From: Felicia Miller
To: Docket Optical System
Date: 4/5/2010 1:35 PM
Subject: Fwd: A2PP - PG&E Gas Pipeline Revised Figure
Attachments: GGS_Habitat_NGLine_032910.pdf; GGS_Habitat_NGLine_032910.pdf; GGS_Habitat_NGLine_032910.pdf

FIGURE 10
GIANT GARTER SNAKE HABITAT WITHIN THE CONSTRUCTION CORRIDOR
 ALMOND 2 POWER PLANT
 CERES, CALIFORNIA

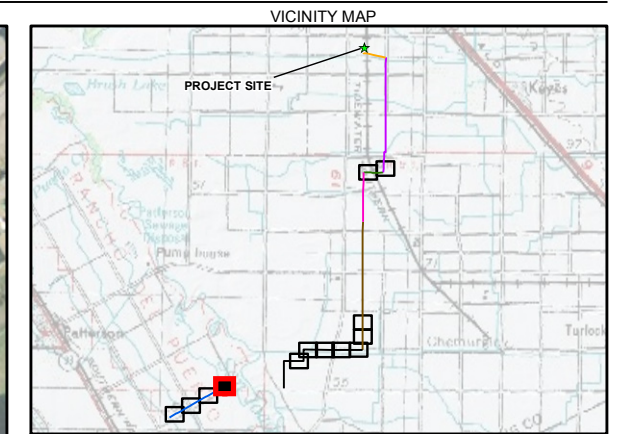
Attached is the revised figure of the PG&E gas pipeline which shows where the pipeline reinforcement will end. It is outside of GGS habitat. Please let me know if you have any questions. Thanks.

Susan – See the attached Prune Ave section that shows the PG&E line ending outside of the GGS habitat! Please share with Felicia and Dave.
